## **FINAL REMEDIAL INVESTIGATION REPORT**

### **REMEDIAL INVESTIGATION AT THE BUILDING 500 AREA ADELPHI LABORATORY CENTER ADELPHI, MARYLAND**

**FEBRUARY 1998**

## **Response to Comments**

Fig 2-1

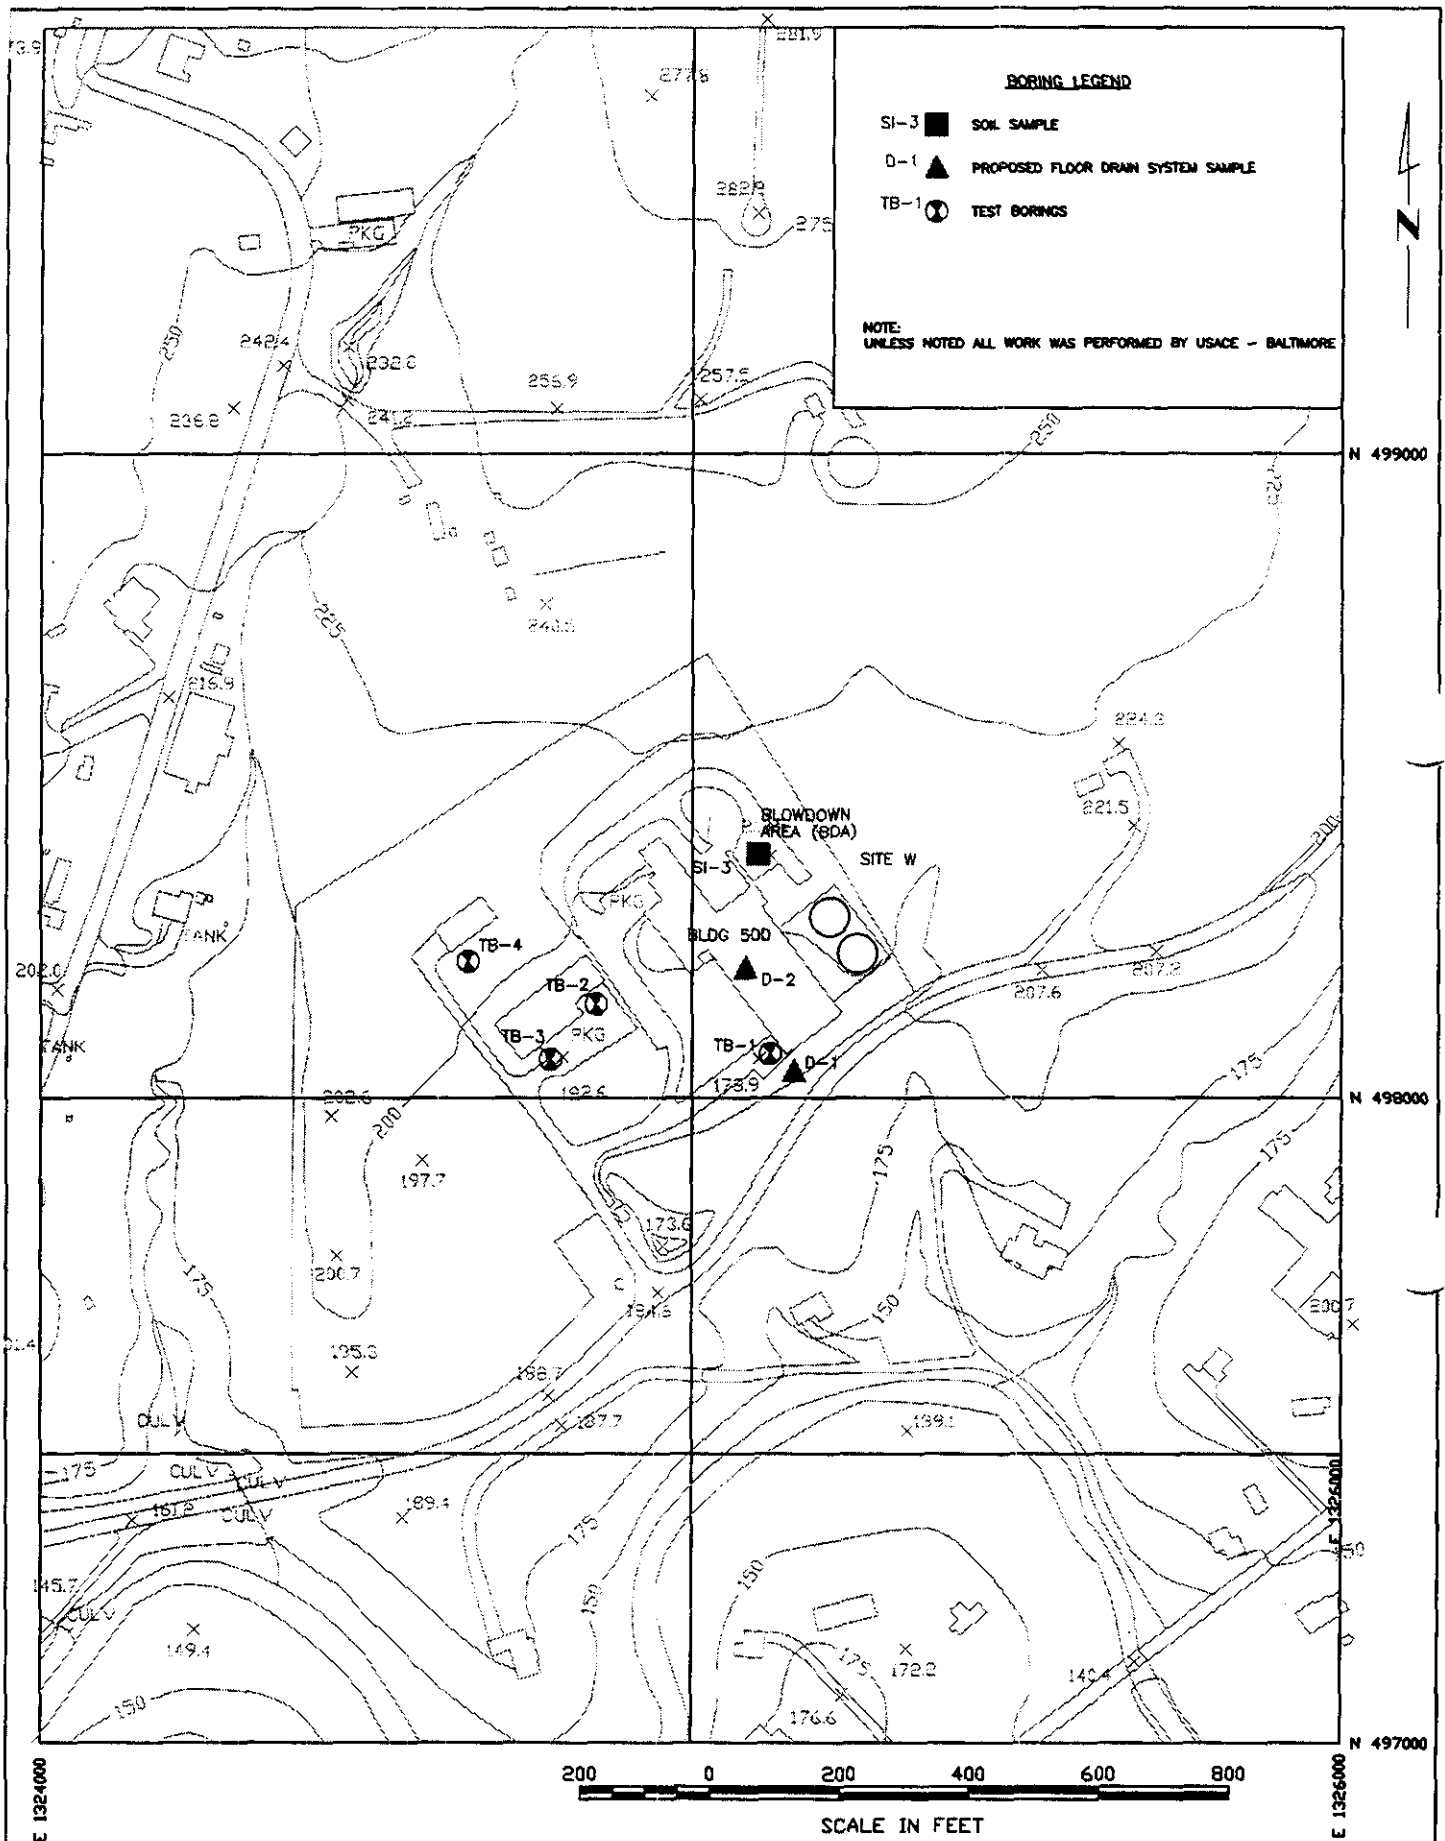
] FIGURE 2-1: Change title to WATER/SEDIMENT SAMPLE LOCATION MAP. The  
] current title is not inclusive of all sampling activities.

Fig 3-6

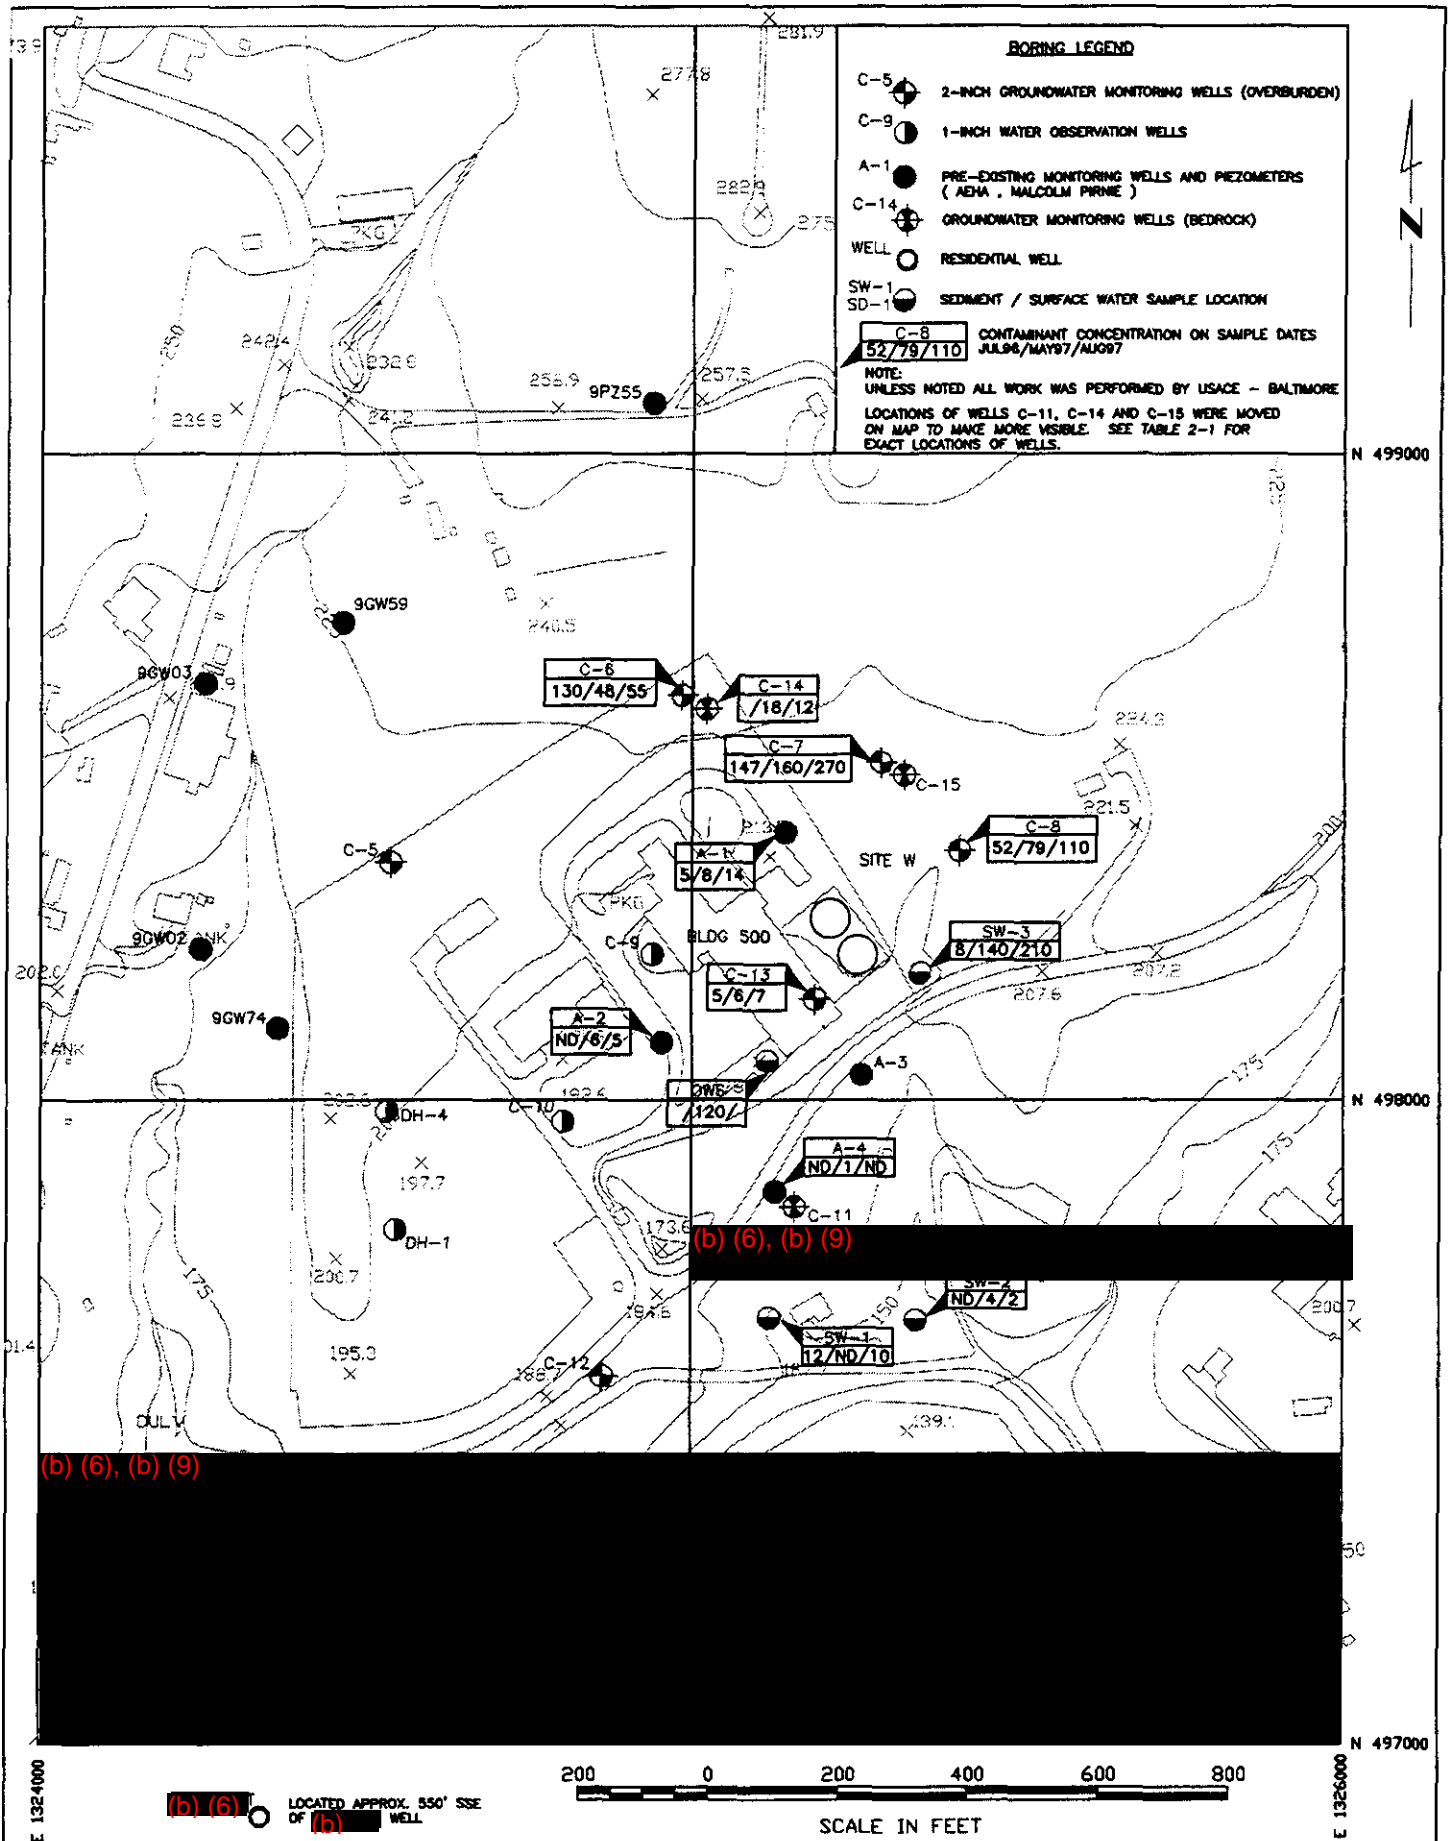
] FIGURES 3-4, 3-5 and 3-6: Add a contour symbol to the legend and the date  
] of the data set used.
